September 6, 2016

ATTN: Harbor Comments

Portland Harbor Superfund Site
Swan Island Sediment Decision Unit Optimized Remedial Alternative

Figure 4: Technology Assignments for Swan Island SDU

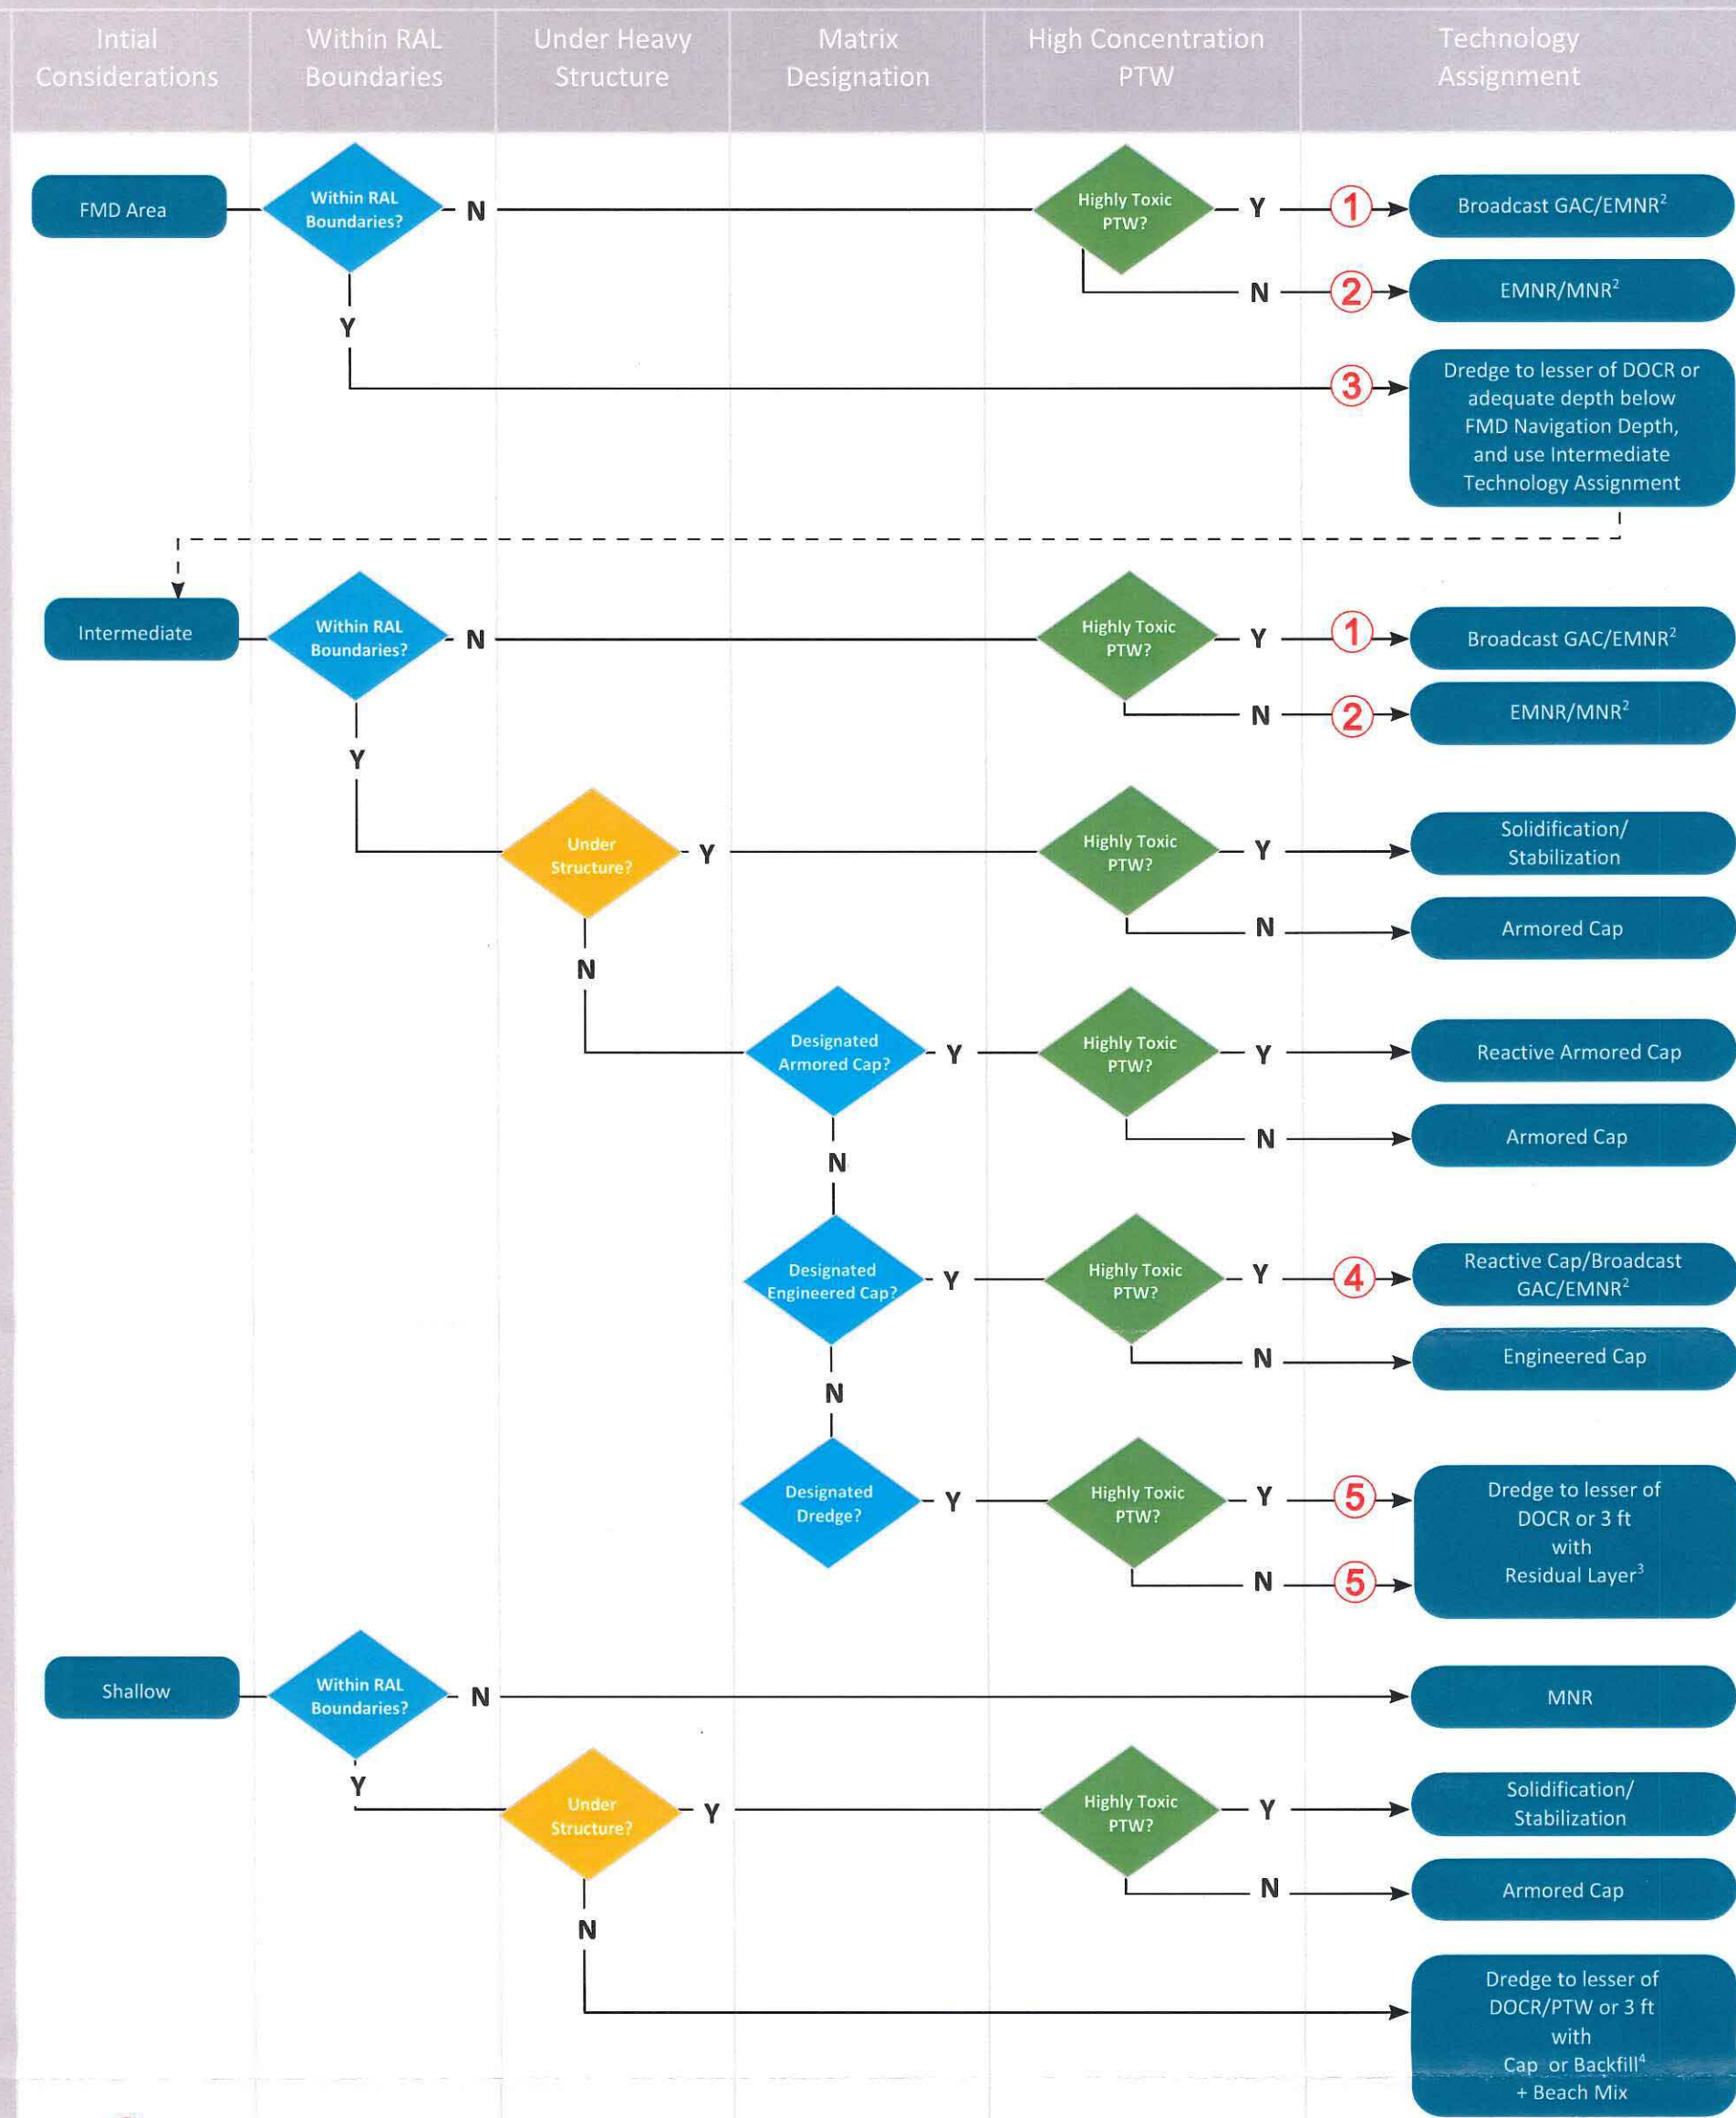
1. Replace "Broadcast GAC" with "Broadcast GAC/ENR" for intermediate regions outside the RAL and within Reliably Contained PTW boundaries. This change differentiates between areas with and without PTW and allows for carbon additions where EPA assigned ENR in Alternatives B–D. It also makes the flow chart consistent with the FS text that states: "ENR is being considered for the area in Swan Island Lagoon that is outside the SMAs to reduce risks. Where PTW is identified, treatment technologies will also be assigned" (EPA 2016b pg 3-30–3-31).

2. Replace "EMNR" with "ENR/MNR" for intermediate areas outside the RAL and outside Reliably Contained PTW boundaries. ENR may not be appropriate in areas of the basin subject to higher bottom shear velocities (e.g., such as at the mouth of the lagoon). Also, ENR may not be needed in all areas if MNR would be appropriate based on local conditions (such as COC concentrations and sedimentation rates). Depending on the different remedy components ultimately selected and the associated overall predicted Surface-Weighted Average Concentrations (SWACs), MNR may be a suitable technology in portions of the SI SDU. This is supported by the recently collected data, as described in Section 2.4.

3. Replace "Dredge to DOCR [Depth of Contamination to be Removed] with Residual Layer" to "Dredge to the lesser of DOCR or adequate depth below FMD navigation depth and use the intermediate technology assignment." Use the intermediate flowchart when FMD area bottom depths are adequately (≥ 3 feet) below navigational depth. The jump from FMD to intermediate technology assignments will allow for optimal technology assignment to the remaining sediment with PCB concentrations above the RAL using the logic of EPA's multi-criteria decision matrix (EPA 2016a Figure 3.4-16) to select the best remedial technology following further design phase studies.

4. Replace "Reactive Cap" with "Reactive Cap/Broadcast GAC/ENR" for intermediate areas that designate Engineered Cap and are within Reliably Contained PTW boundaries. This change allows for flexibility in assigning the appropriate technology if an area of the SI SDU were to be "designated as Engineered Cap." We believe that if Broadcast GAC/ENR technology is applicable to Reliably Contained PTW as presented by EPA in Alternatives B–D, then it is logically consistent that the technology should also be applicable to the same areas in all alternatives, or at least retained for further consideration during remedial design.

5. Replace "Dredge to DOCR/Reactive Residual Layer" with "Dredge to the lesser of DOCR or 3 ft with Residual Layer³" for intermediate areas that designate "Dredge" and are within Reliably Contained PTW boundaries. Explanatory footnote # 3 states that "If DOCR is greater or equal to 3 ft apply Reactive Residual Layer."
